AMENDED IN RED

Approval no: DEV2019/1082

Aura Precinct 10

Noise Impact Assessment

Figure
C.1

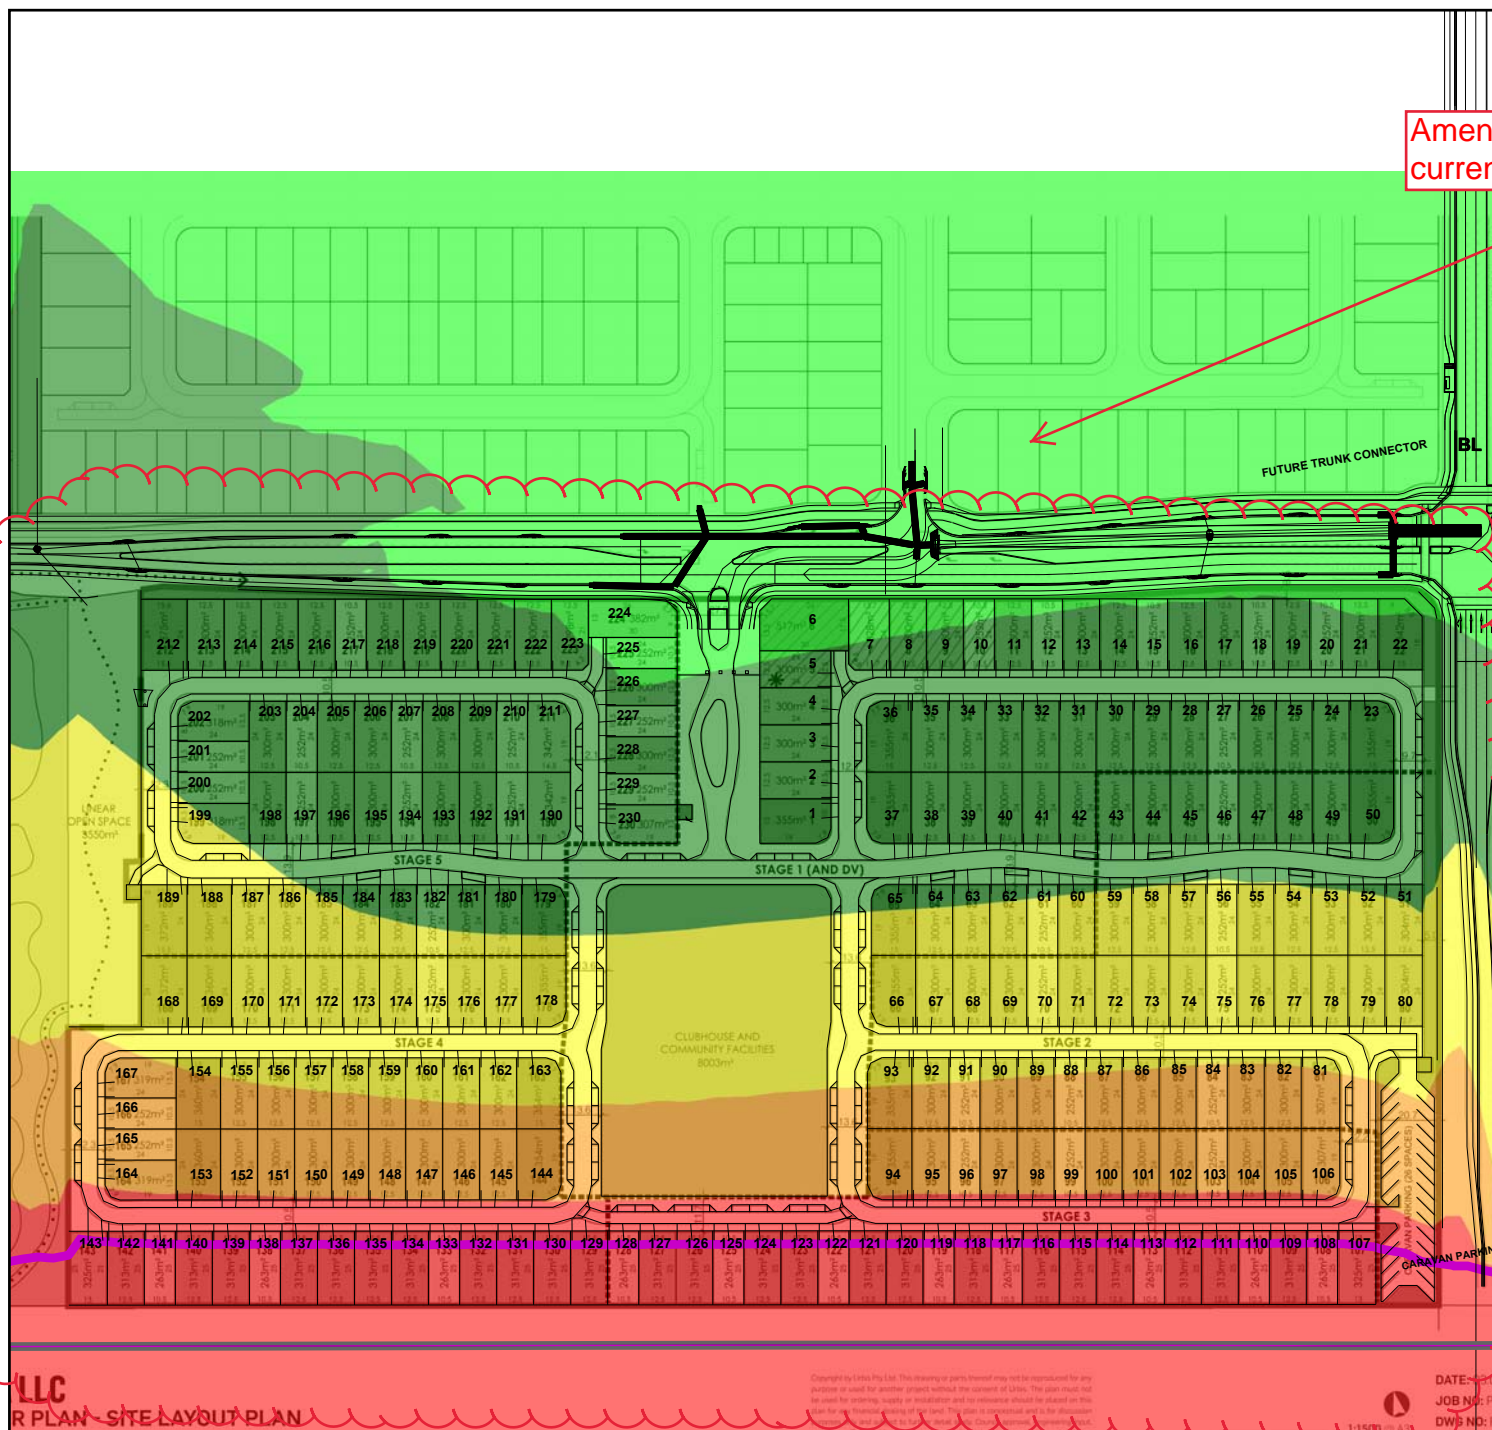
Amend to reflect
current layout

Figure
D.1

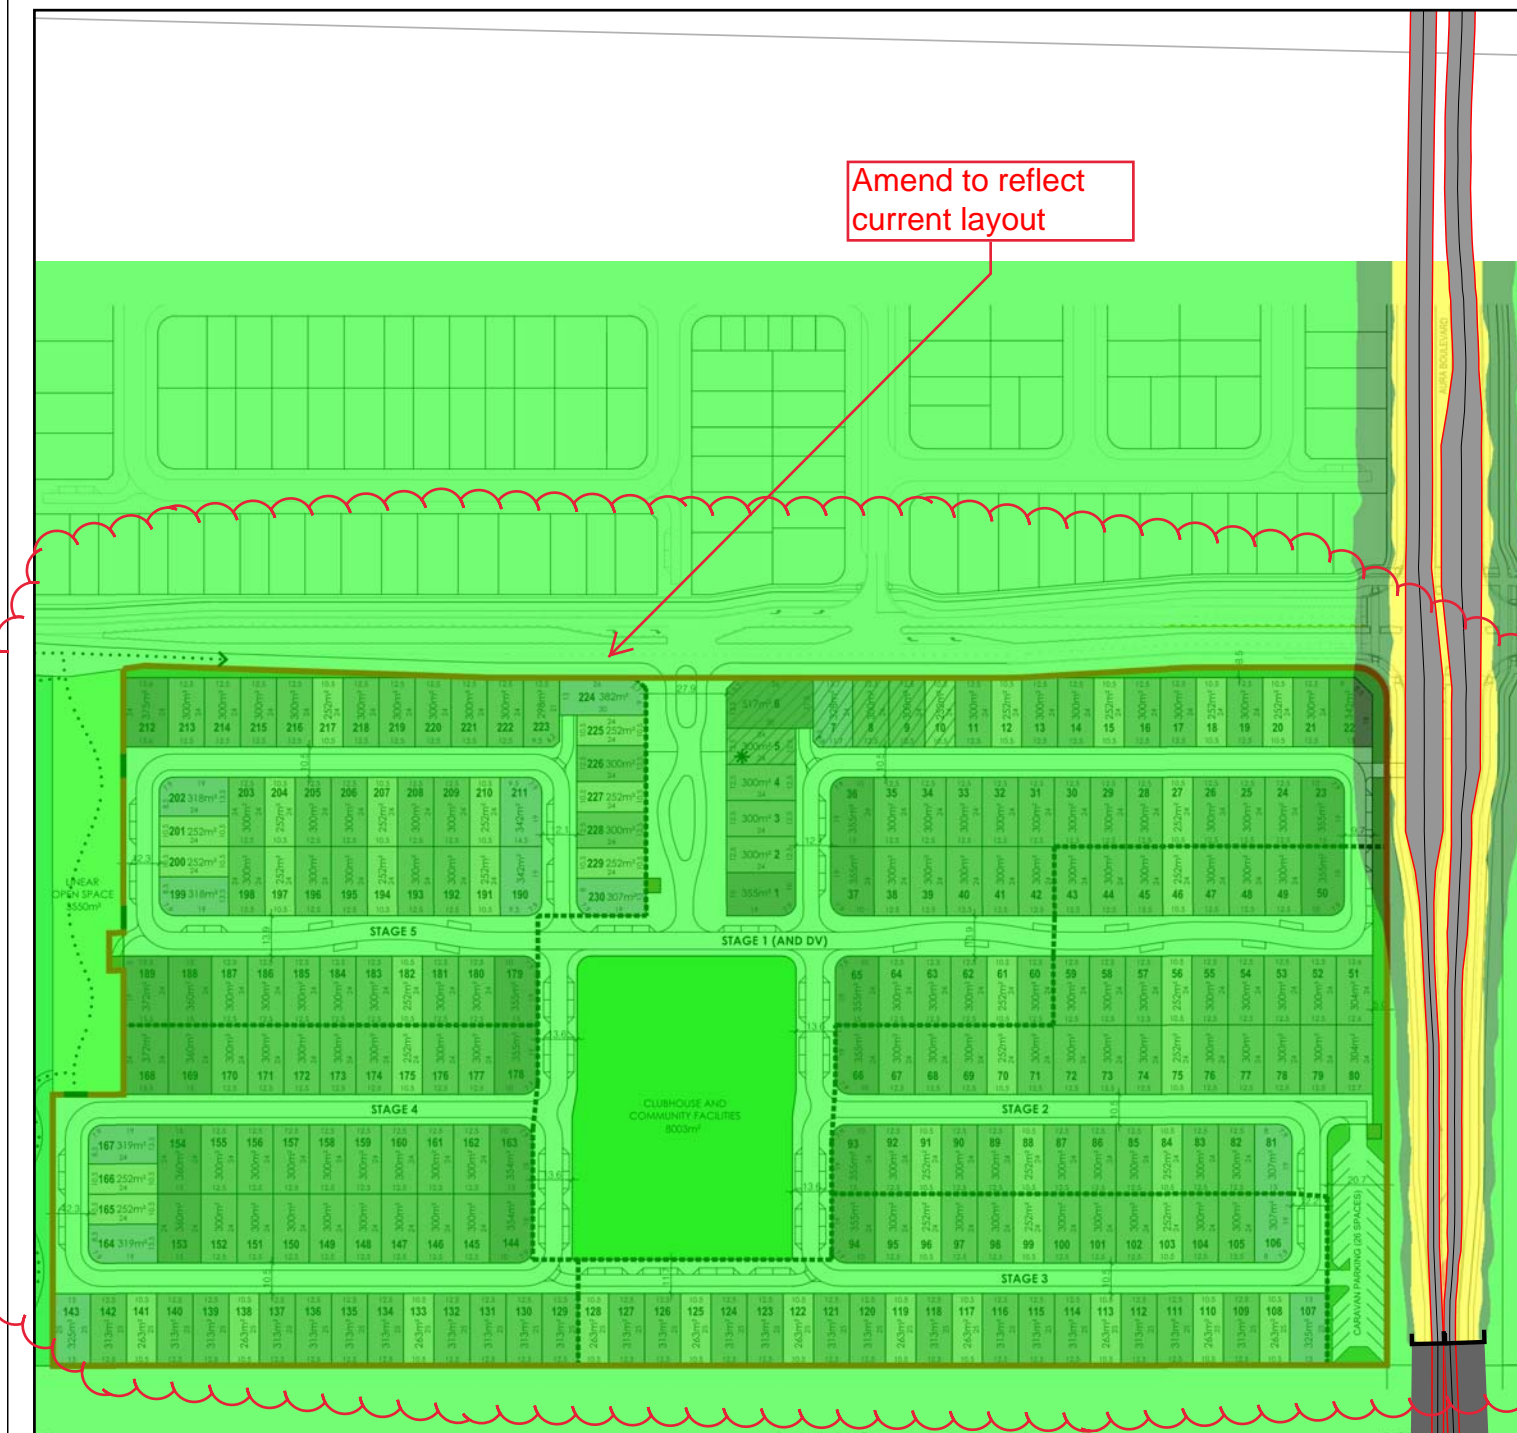
Amend to reflect
current layout
